**DOCKET NUMBER 50-483
CALLAWAY PLANT
UNION ELECTRIC COMPANY
RESPONSE TO REQUEST FOR ADDITIONAL INFORMATION
ON REVISION TO TECHNICAL SPECIFICATION 5.5.9
"STEAM GENERATOR (SG) TUBE SURVEILLANCE PROGRAM"**

**REQUEST FOR ADDITIONAL INFORMATION
REVIEW OF THE CALLAWAY PLANT APPLICATION
FOR REVISION TO TECHNICAL SPECIFICATION 3/4.4
TAC NUMBER: MB1214**

Figure R6-27

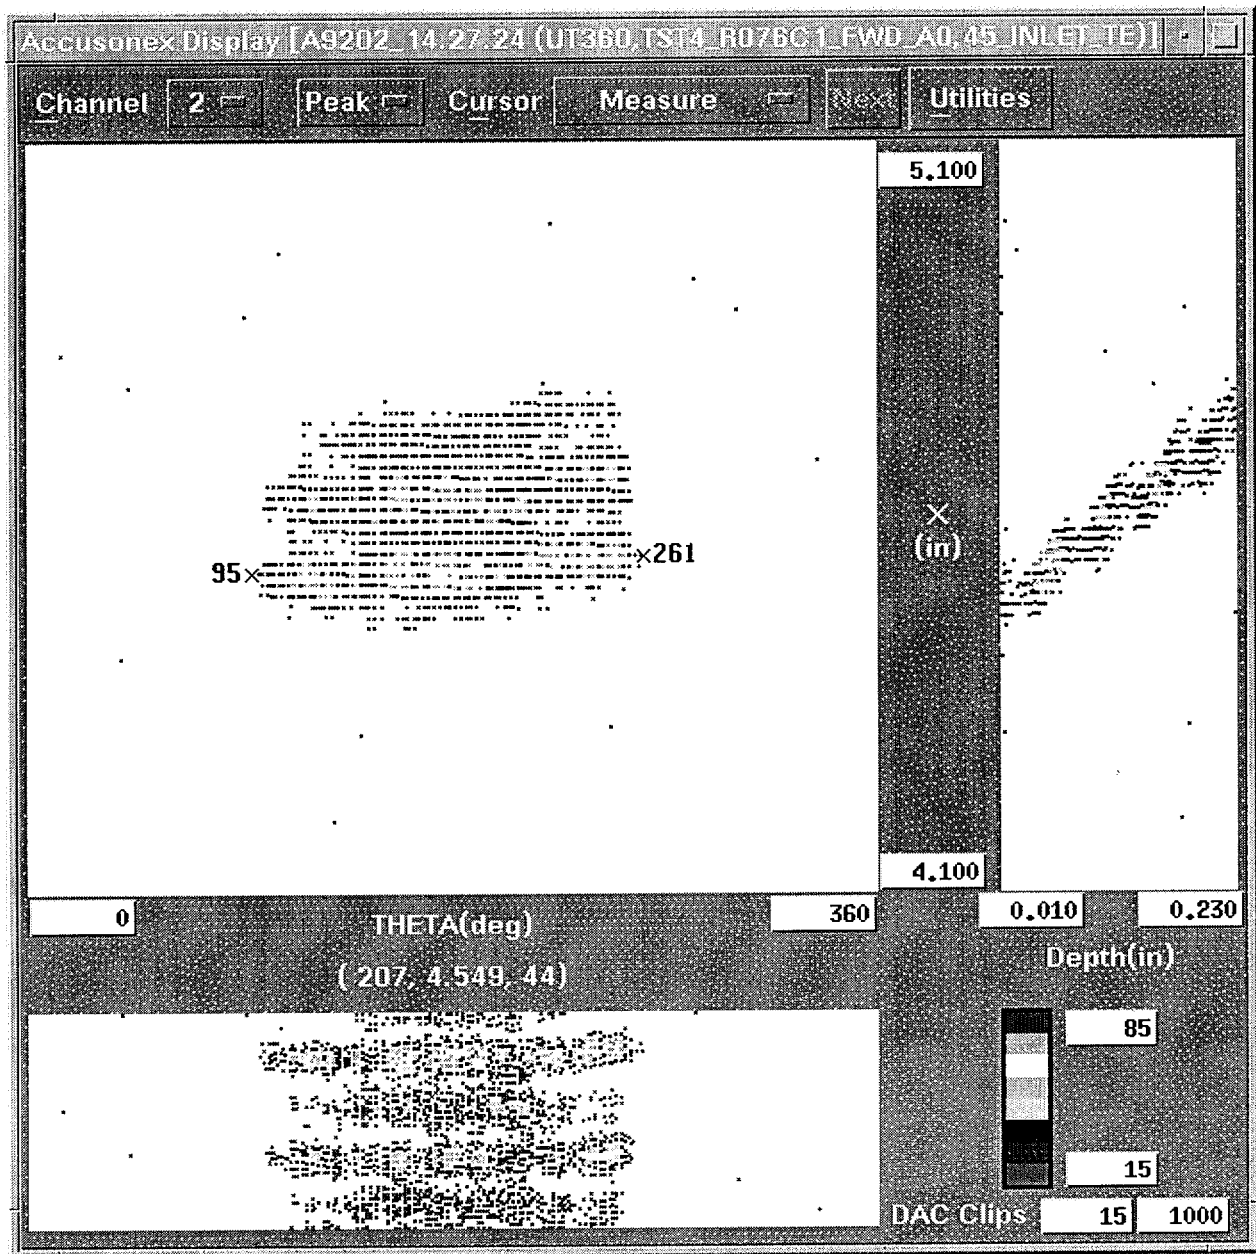
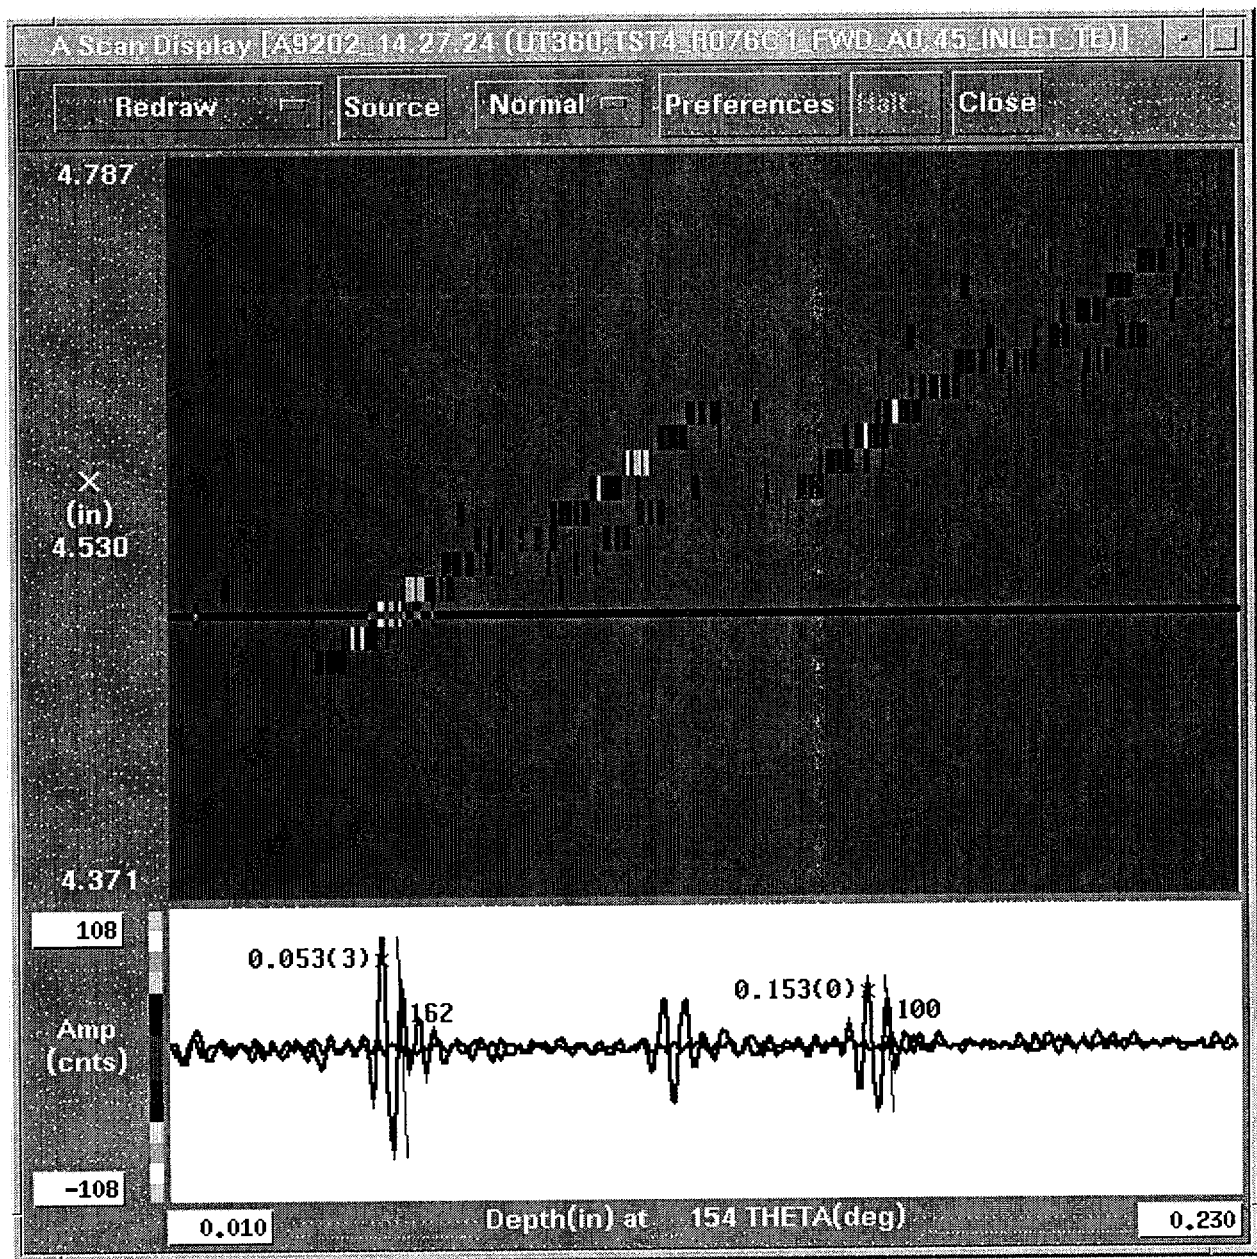
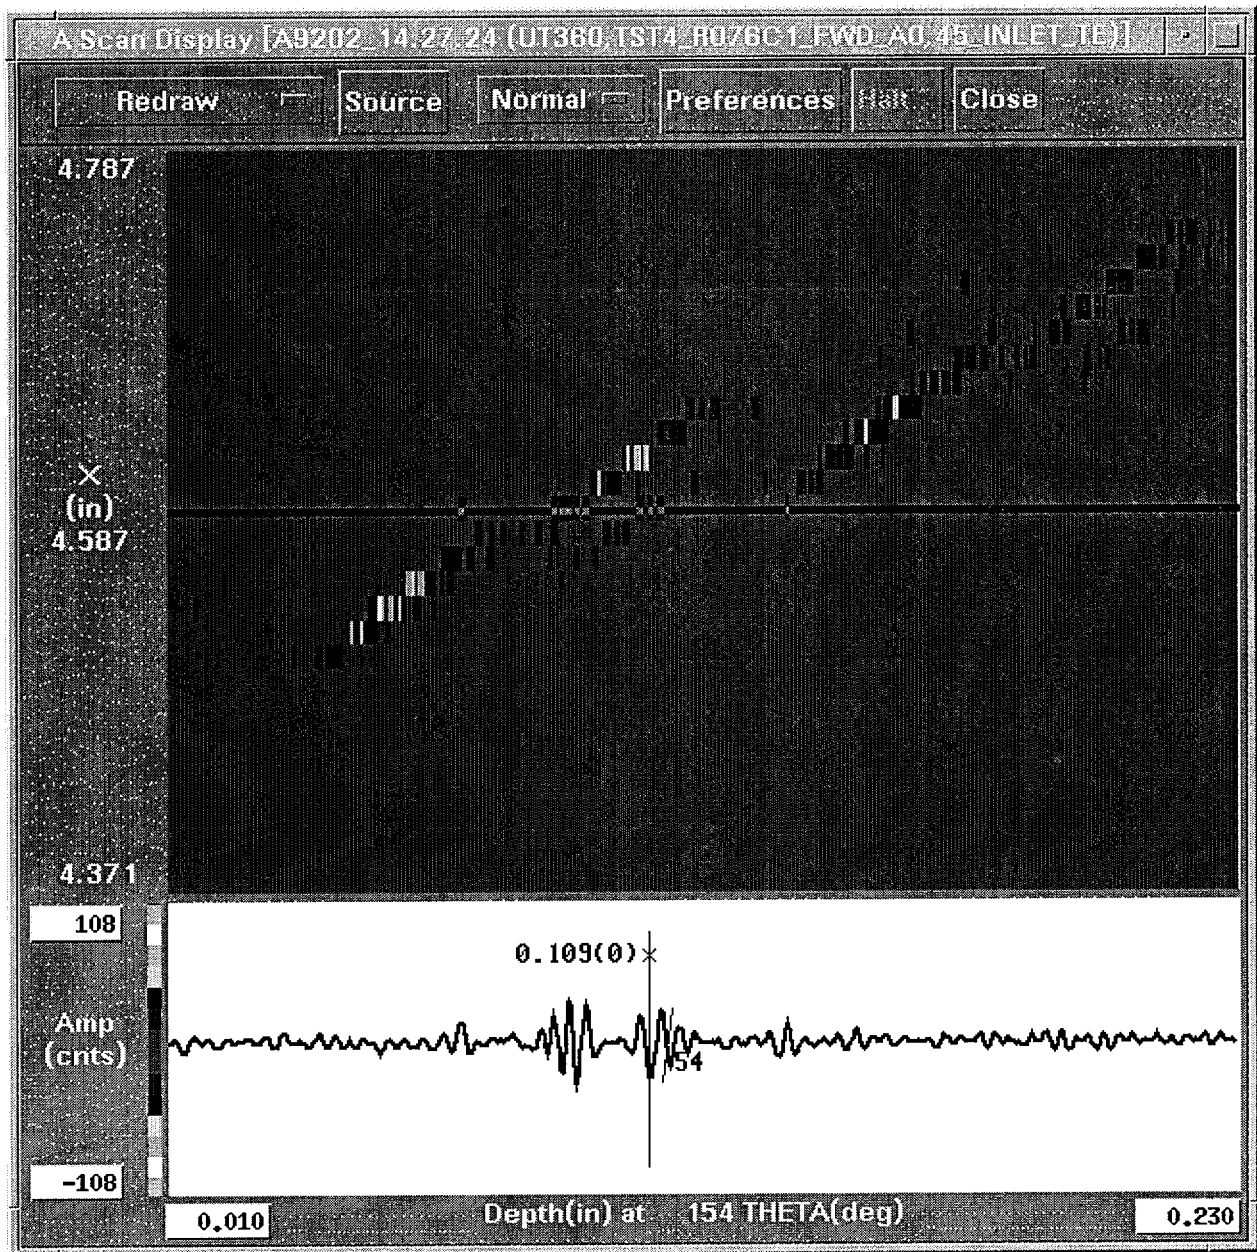
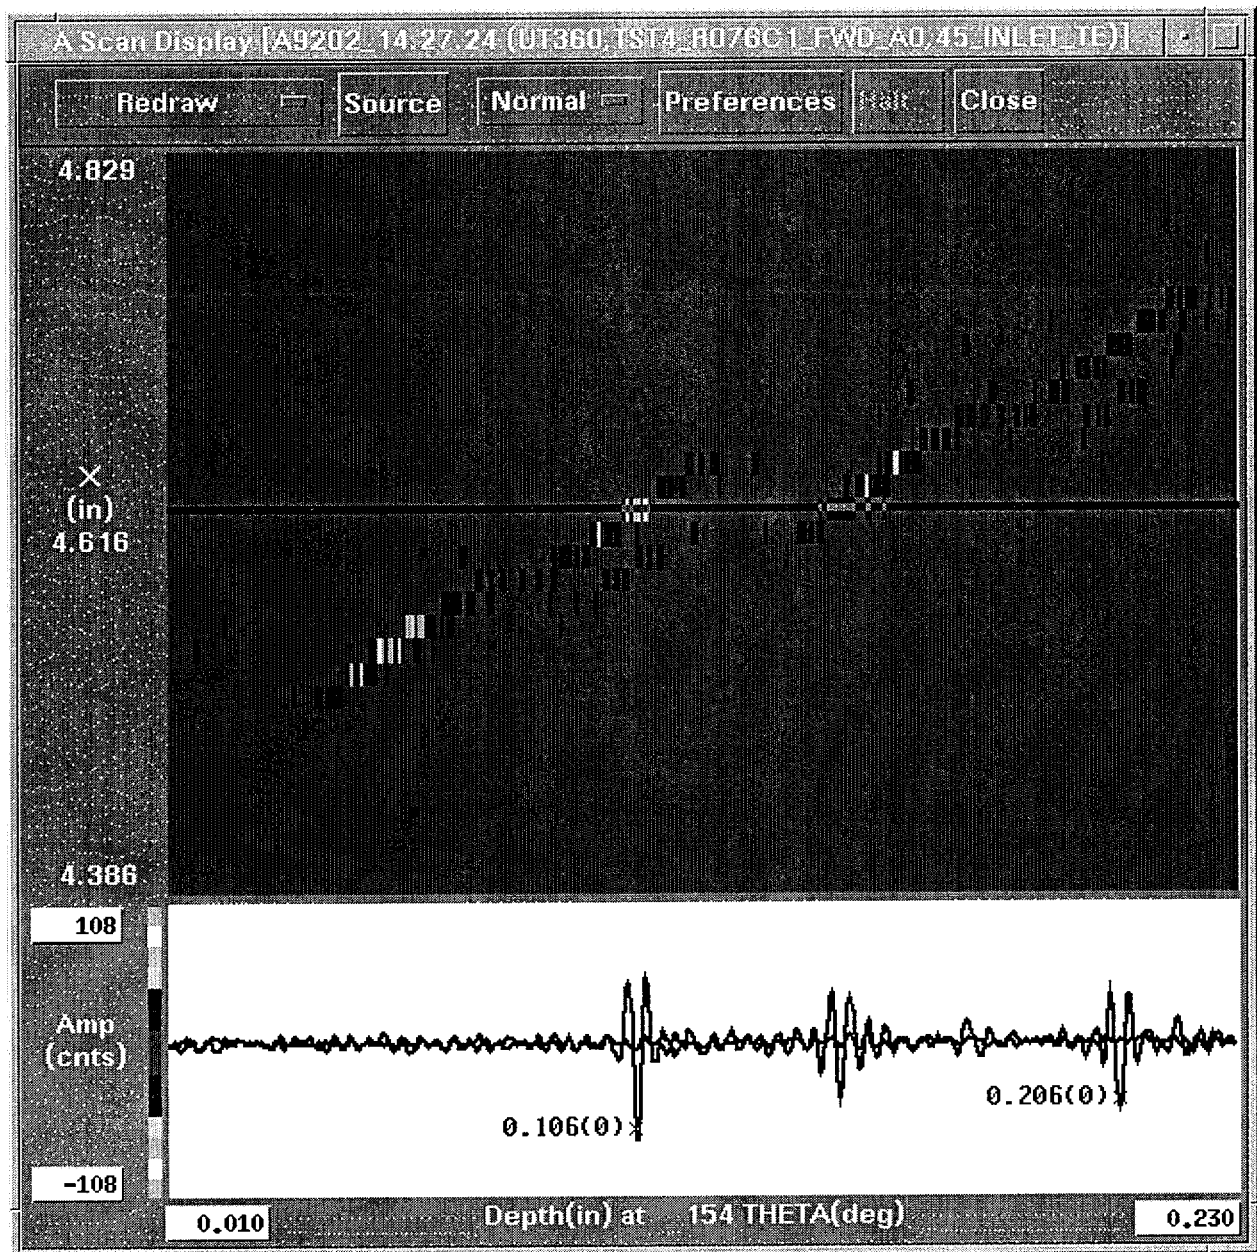
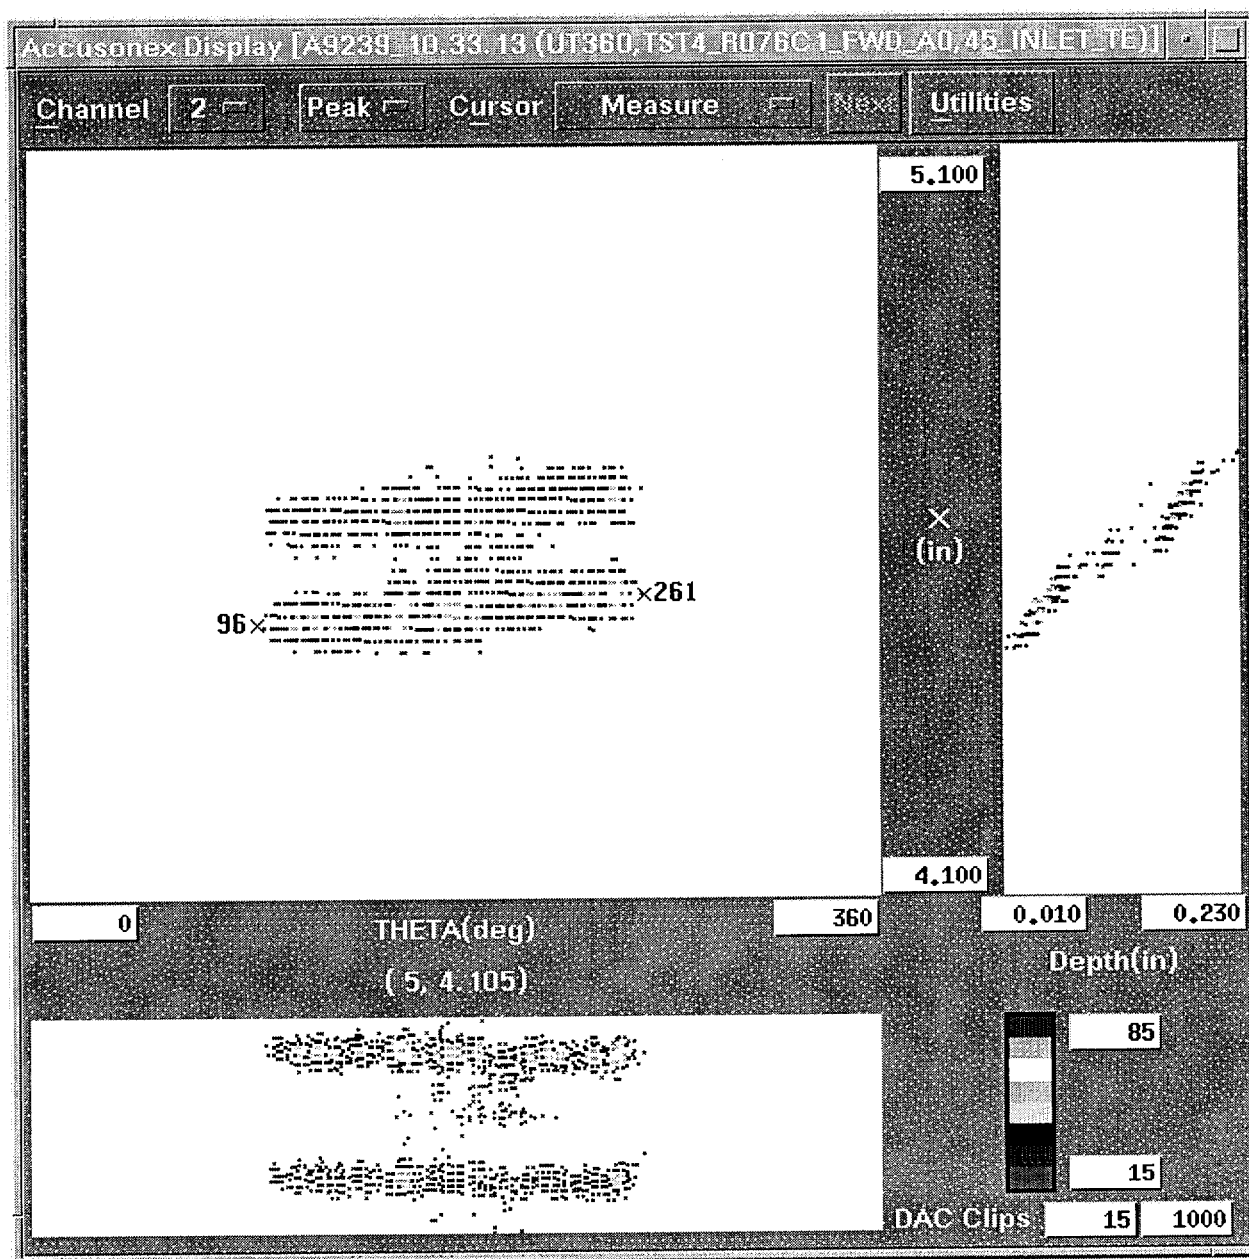
RAI # 6. During the meeting, FTI indicated that PWSCC detectability in the sleeve could be inferred from the ID notches in the UT calibration standards and the data sets containing pits. It is not clear to the staff how detecting EDM notches in the calibration standards or another degradation morphology such as pits would infer an ability to detect tight flaws such as PWSCC. Explain the basis for the statement that sleeve PWSCC ID defects will be detected, and the resulting sensitivity and POD, since the peer review (ETSS # 98404) only covers volumetric defects. Please provide additional discussion or, preferably, additional data to support the claims of the capability of the technique to detect PWSCC in the sleeve. (Question from the 6/7/01 meeting held with UE, FTI, and the NRC staff)

During the fatigue cycling, fatigue cracks developed in the sleeve wall at the inner diameter crack site as well as at the outer diameter crack site. The post fatigue portion of this presentation will show the return of the full skip reflection at the inner diameter crack location as well as the increase in the FSN result for the outer diameter crack.

This is the pre-sleeve C-Scan plot of the ODSCC circumferential crack in tube TST4-076-1. The outer diameter crack extent (length) can be estimated from the C-Scan plot as $(261 - 95)$ or 166 degrees. The plot shows the presence of a half skip response, a one and one half skip response and a considerable amount of full skip and two skip reflections.

This is the post sleeve (pre-fatigue) C-Scan plot of the ODSCC circumferential crack in tube TST4-076-1. The outer diameter crack extent (length) can be estimated from the C-Scan plot as (261– 96) or 165 degrees. The plot shows the presence of a half skip response, a one and one half skip response and some full skip reflections between the 170 degree and 220 degree locations.

This is the post fatigue crack C-Scan plot of the ODSCC circumferential crack in tube TST4-076-1. The crack extent (length) can be estimated from the C-Scan plot as $(261 - 94)$ or 167 degrees. The plot shows the presence of a half skip response, a one and one half skip response and the return of the full skip reflections.
